Architectural Review and
Historic Preservation Board
Agenda Report

File: AR 15-26

RE: Architectural Review 15-26 (LaSalle's/Griffith) - 229 and 233 Broadway
Facade remodel and new outdoor dining patio

ADDITIONAL DETAIL REQUESTED BY ARHPB 10.14.2015 ITEM 3
FAÇADE RENOVATION & OUTDOOR CAFÉ SEATING
for 229 & 233 BROADWAY, Chico, California

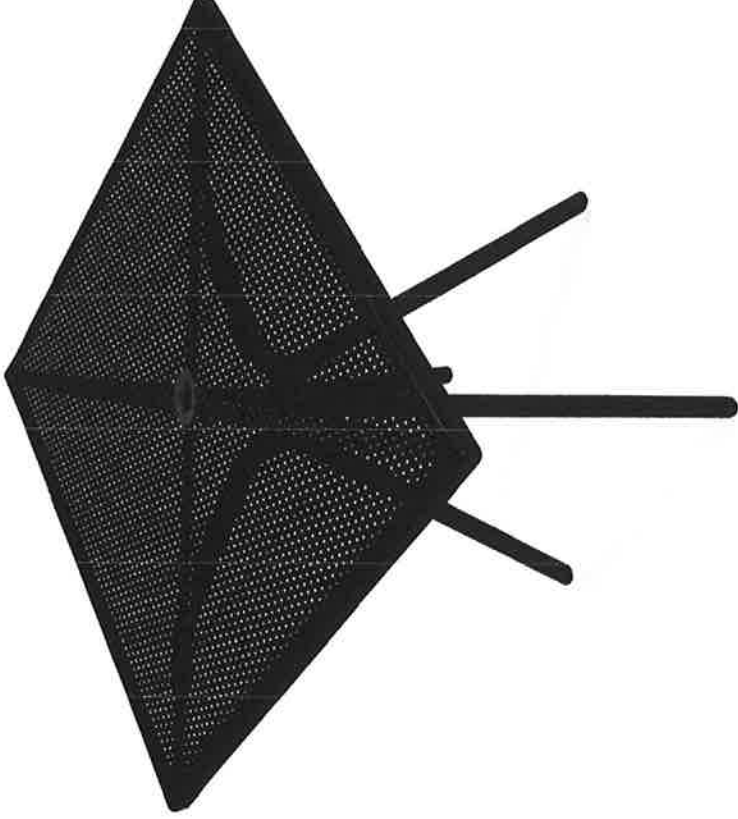
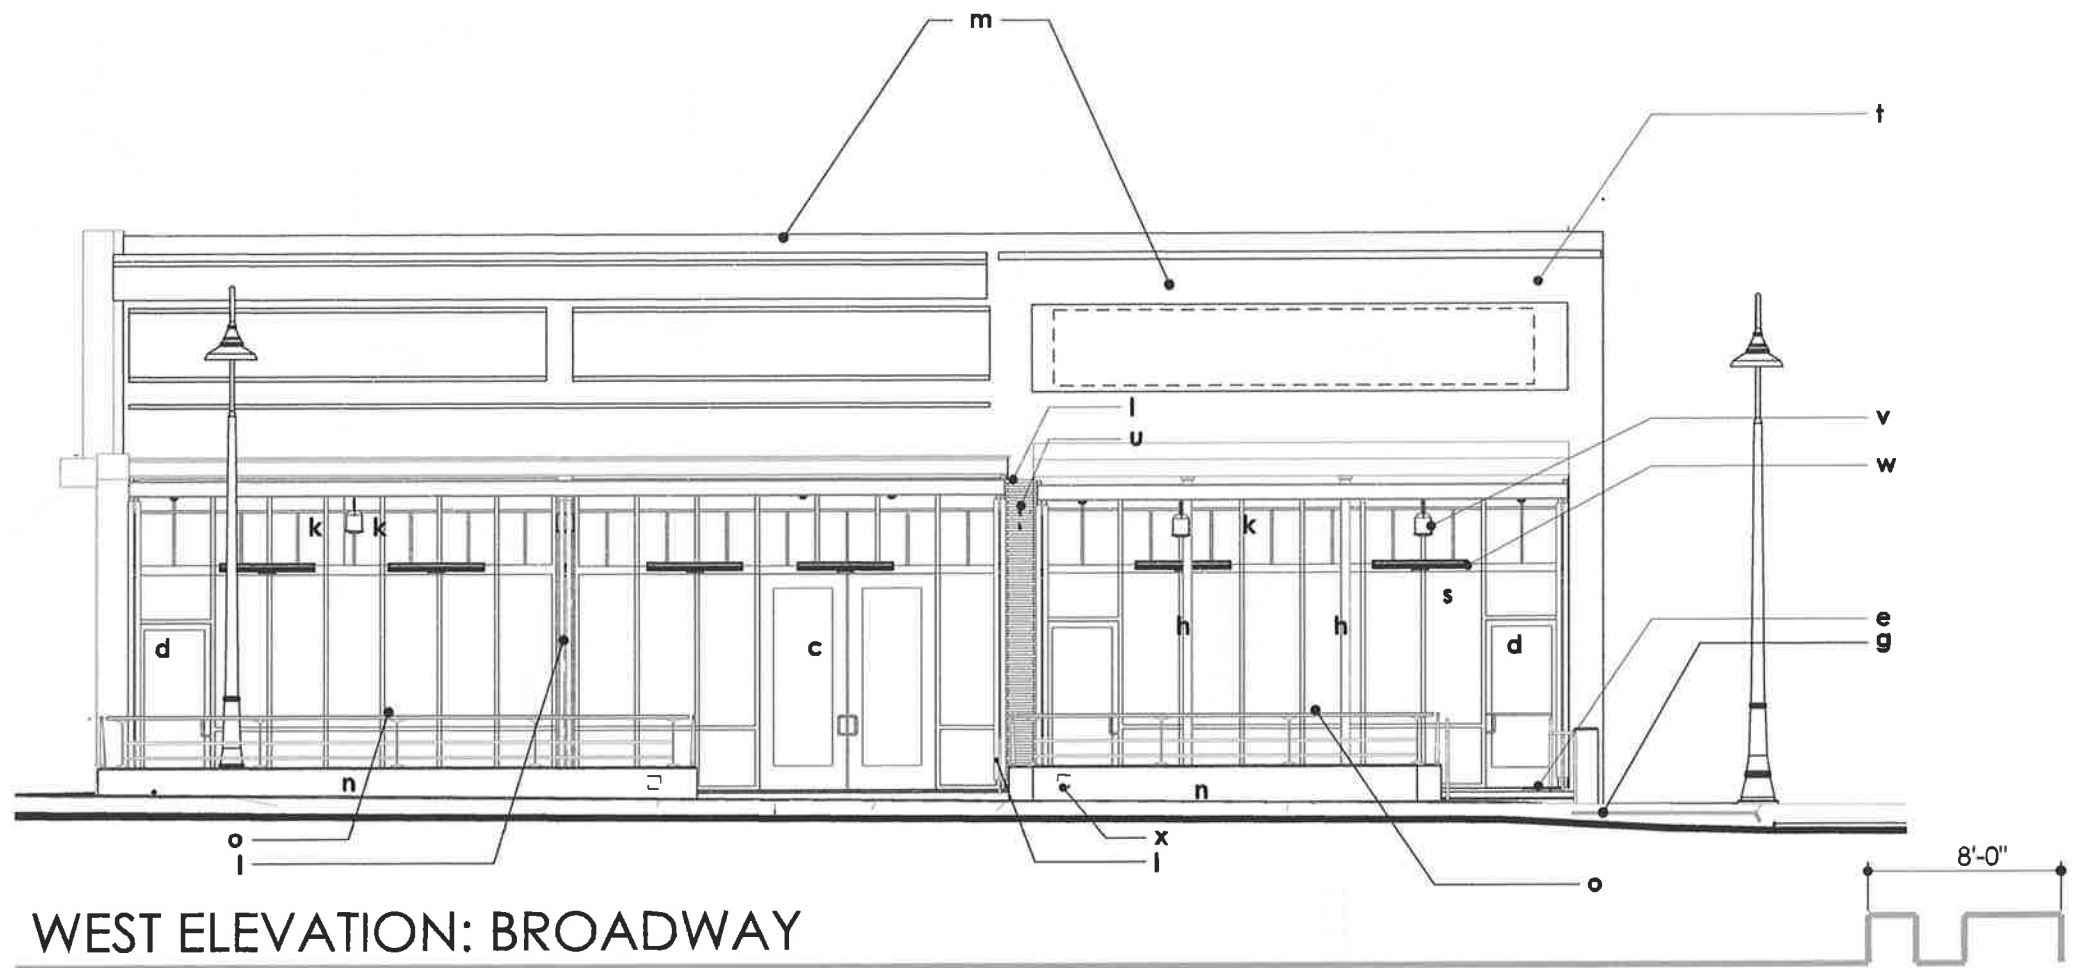
3. Outdoor dining furniture. *Confirm that the style presented at the meeting will be utilized, or an alternate style. (The design presented to the Board was overall acceptable.)*

Staff response: The proposed furniture is the same as was presented at the previous meeting, with cut sheets attached to this report. The black chairs and charcoal tables are consistent with Design Guideline 1.3.44 calling for black furniture with classic lines in the Downtown. Similar black furniture was approved for the Celestino's patio.

- 3. Outdoor Dining Furniture....**An outdoor dining furniture cut sheet was presented informally at the October 7 meeting, and is now confirmed. A copy of the manufacturers cut sheet is attached.

ADDITIONAL DETAIL REQUESTED by ARHPB 10.14.2015 ITEMS 4&5,8,10&11
 FAÇADE RENOVATION & OUTDOOR CAFÉ SEATING
 for 229 & 233 BROADWAY, Chico, California

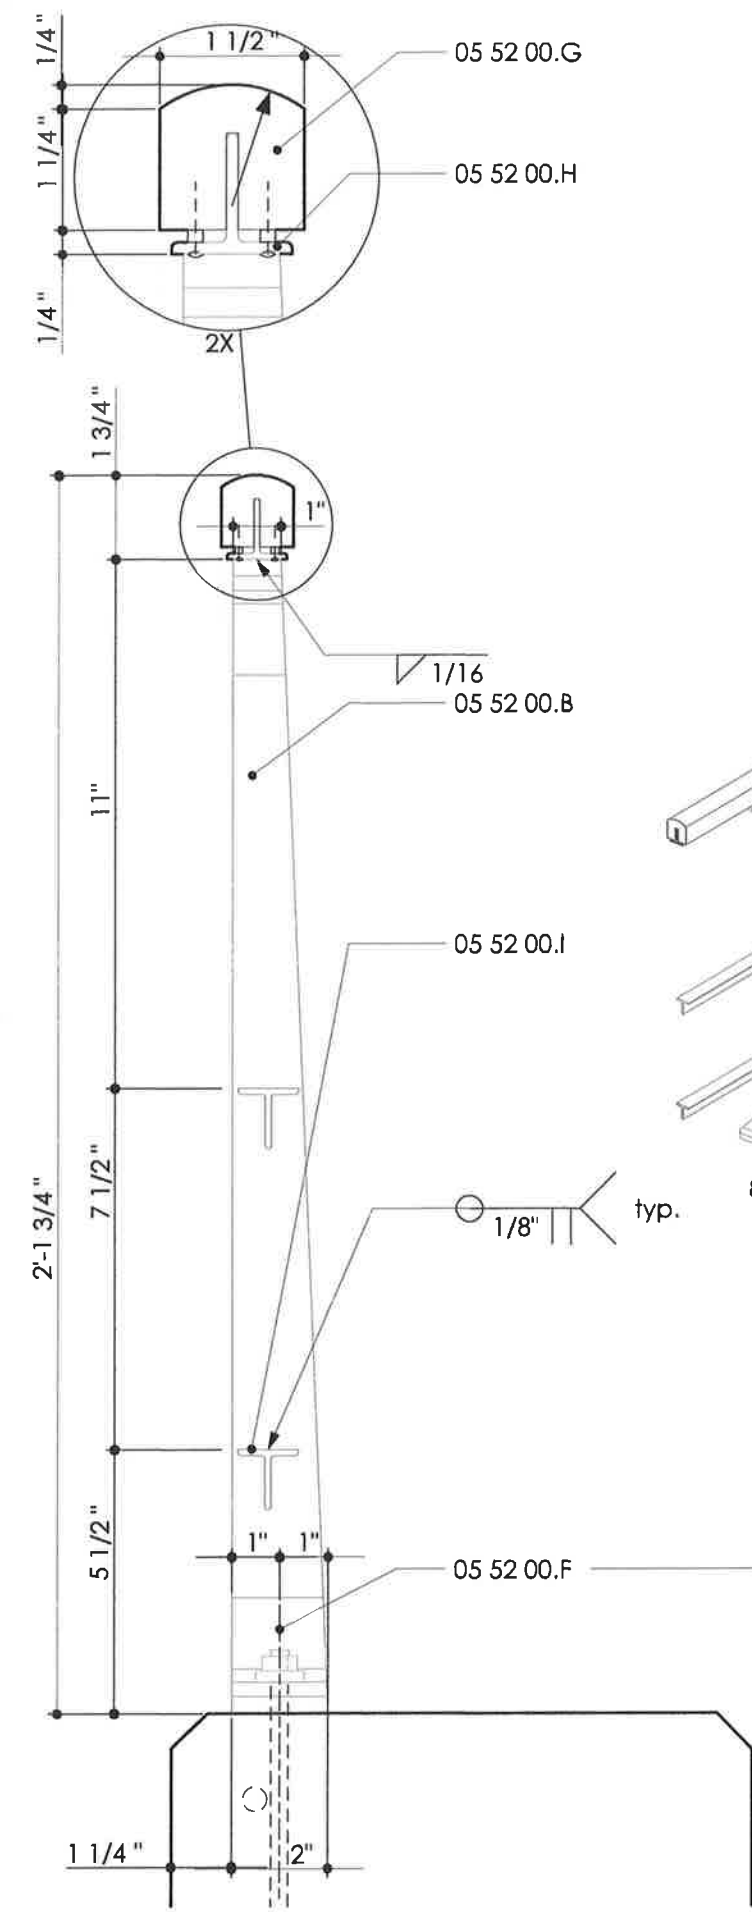
4. Design of front entry doors. *Clarify finish, color, and details such as glass portions.*

5. Signage. *Although the name of the restaurant does not need to be presented, parameters of the general size, location, lighting, and design of the signage should be established. Final name and design can be delegated to planning staff.*

8. *Finalize any details to painting the brick parapets. The Board appeared to generally support the unified gray-green color proposed across the parapets.*

10. *Provide cut sheets and/or diagrams of heating fixtures.*

11. *Indicate the location of irrigation stubs should any decorative landscape planters be proposed.*

Staff response: The design is clarified on the attached *West Elevation: Broadway diagram*. Tall "Ipe" wood doors with glass panels are proposed, the wood matching the Ipe wood trellis system previously reviewed and supported by the Board. (Samples of the Ipe wood will be presented at the meeting, and material/color sheets are attached.

Staff response: Two color perspectives of the front elevation are attached which illustrate day and night scenarios of proposed signage. Located on the northerly parapet wall (not over the decorative brickwork of the southerly parapet), the wall sign is comprised of individually illuminated channel letters. (Note that the name on the perspectives is only for design purposes.) Staff also recommends the Board discuss whether halo illumination of the wall sign may be more in keeping with the up-scale, sophisticated design of the proposal, rather than internally illuminated channel letters.

Staff response: As noted above and described by the architect on his cover letter, the applicant prefers the single color of the decorative brick parapet, and extending the same color to the northerly parapet. Staff supports this proposal as being historically accurate and consistent with other brick parapets in the Downtown.

- 4. Design of front entry doors.** The revised elevations and rendering show the current door design, which is constructed using ipé wood and glass.
- 5. Signage** Location and nature of the proposed signage (although not the restaurant name) has been added to the building elevation and rendering, see attached revised building elevation and the revised rendering. Note that the wall sign will consist of individual internally lit channel letters. No projecting sign is proposed. A blade sign is also proposed. It is requested that the blade sign allowable area of 4 sf be increased by the allowable area for projecting signs, making the blade sign a possible total of 8 sf.

- 8. Finalize any details to painting the brick parapets.....** At the October 7 meeting, discussion turned to the concept of picking out the brick detail of the north facade with a two-tone color scheme. After some consideration, I cannot support this idea. As shown on the Historic Context sheet presented earlier—in all three photos, from three different eras-- the north building was always painted a single color, allowing the brick detailing to stand out architecturally rather than superficially. Our intention of

painting the brick a single color --KM5748-5 Nature's Gate--returns the north building to its original concept, and extends the concept to the south building, unifying the two in a continuous façade.

8.1 SECTION RAIL 05 52 00.A

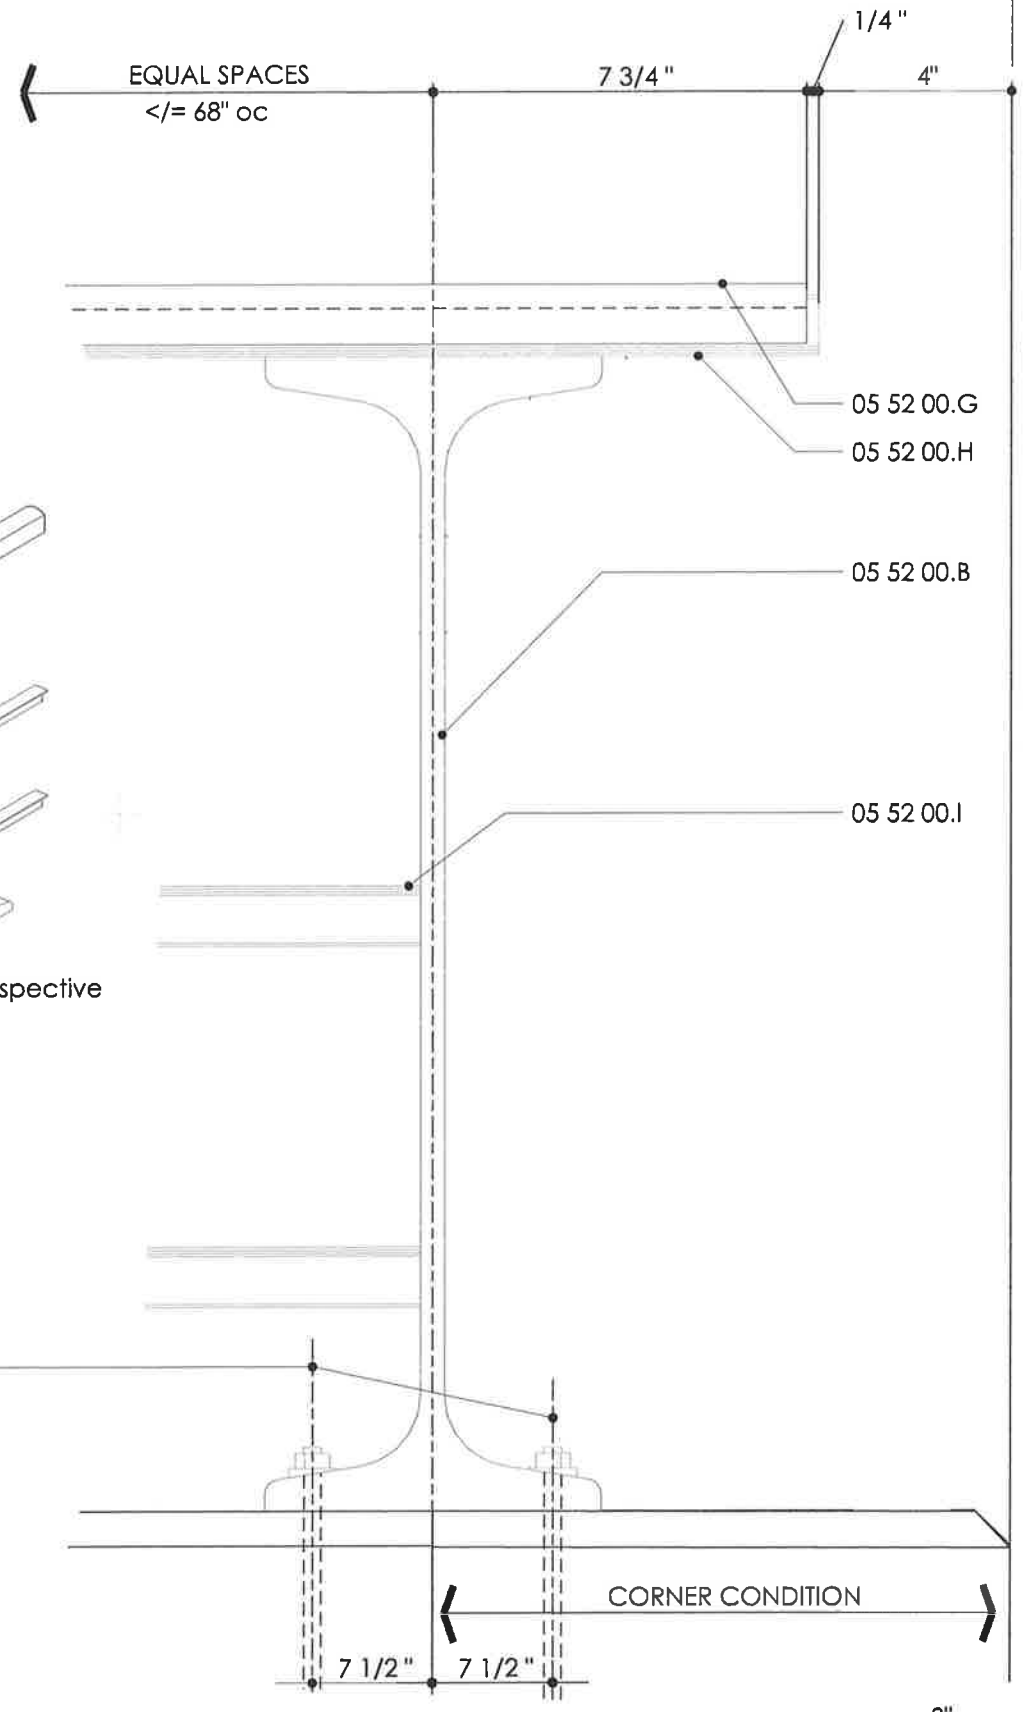
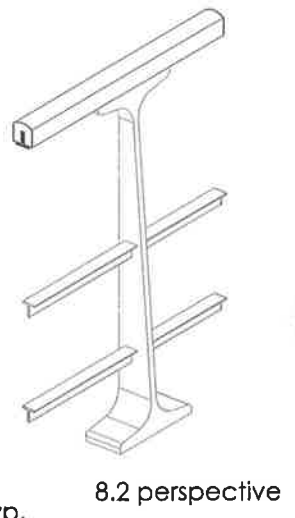
6. Patio railing design. *The revised railing design presented at the meeting was generally acceptable to most of the Board members (although not unanimously supportive of the low concrete wall). Any final design details or adjustments should be presented to the Board.*

Staff response: Details of the proposed railing are included in the resubmittal package which maintains the low concrete wall finished with a similar, slightly darker tint (via the addition of lamp black) as the patio floor.

- 6. Patio railing design....** The outdoor café railing is shown on the revised elevation and rendering, as well as the attached detail, excerpted from the working drawings now in progress.

ADDITIONAL DETAIL REQUESTED by ARHPB 10.14.2015 ITEM 9
FAÇADE RENOVATION & OUTDOOR CAFÉ SEATING
 for 229 & 233 BROADWAY, Chico, California

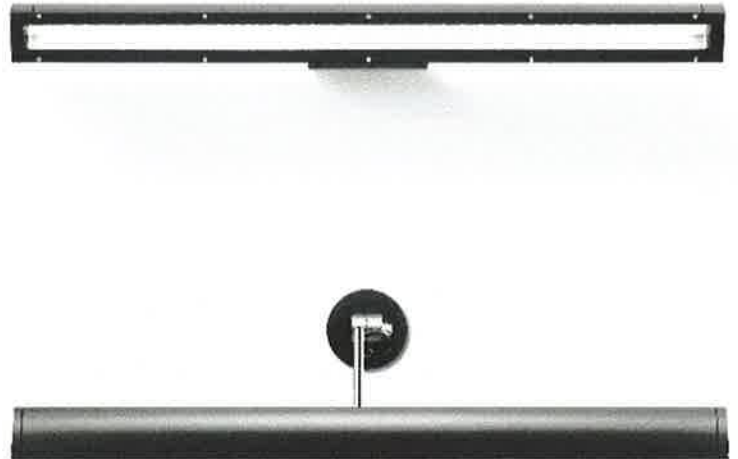
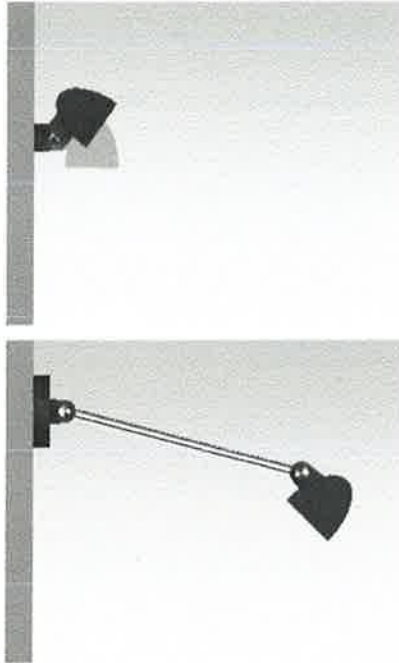
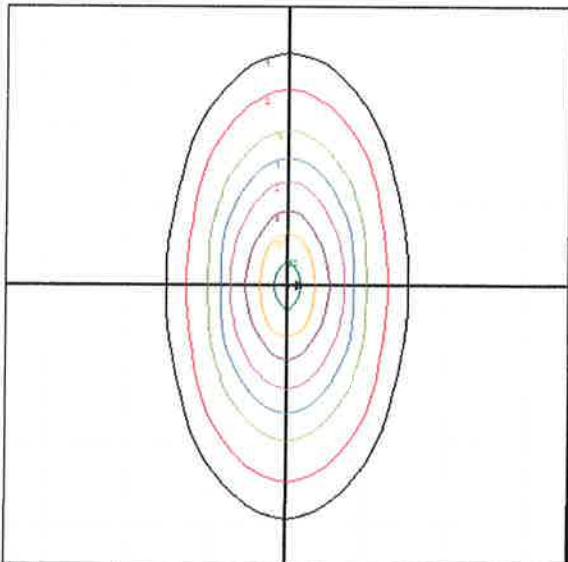
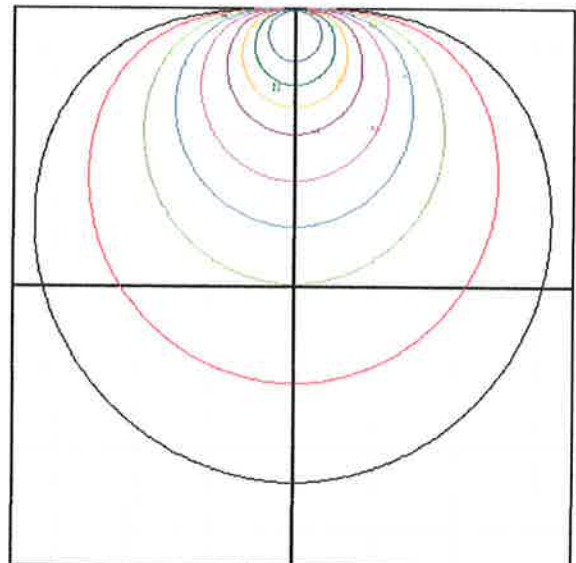
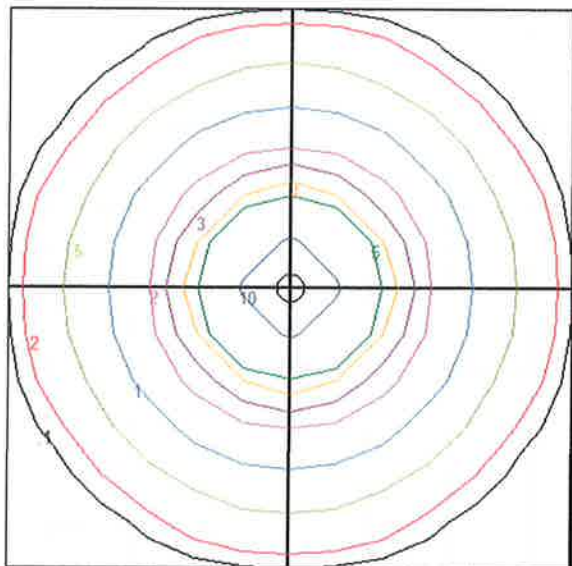
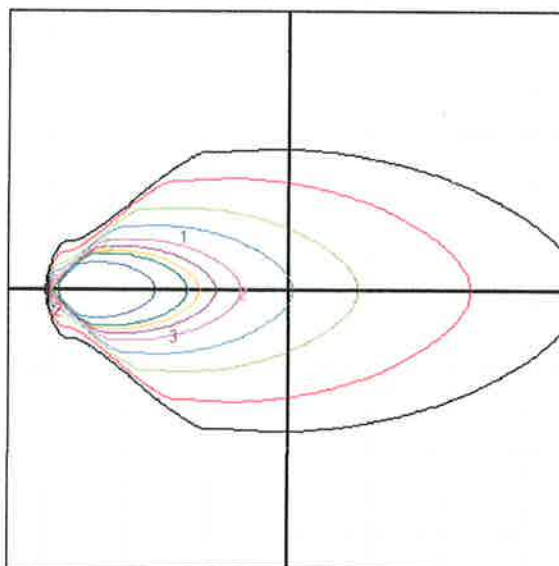
9. *Provide manufacturer cut sheets of light fixtures.*

Staff response: Cut sheets provided in the resubmittal package indicate the spot lights are small, marine-grade die-cast aluminum fixtures. Staff cautiously supports the lighting proposal, however, any light that shines above the slatted awning would need to be adjusted or removed (see recommended conditions).

9. **Manufacturer cut sheets of light fixtures**.... Cut sheets for the two light fixtures included in the revised renderings are attached, with annotations regarding output and color temperature.
10. **Cut sheets and/or diagrams of heating fixtures** Gas-operated radiant heat fixtures have been added to the design model and are visible in the revised elevations and renderings. Manufacturer's cut sheets are attached.
11. **Location of irrigation stubs** Recessed boxes for hose bibbs and future irrigation connections are noted on the revised elevations.
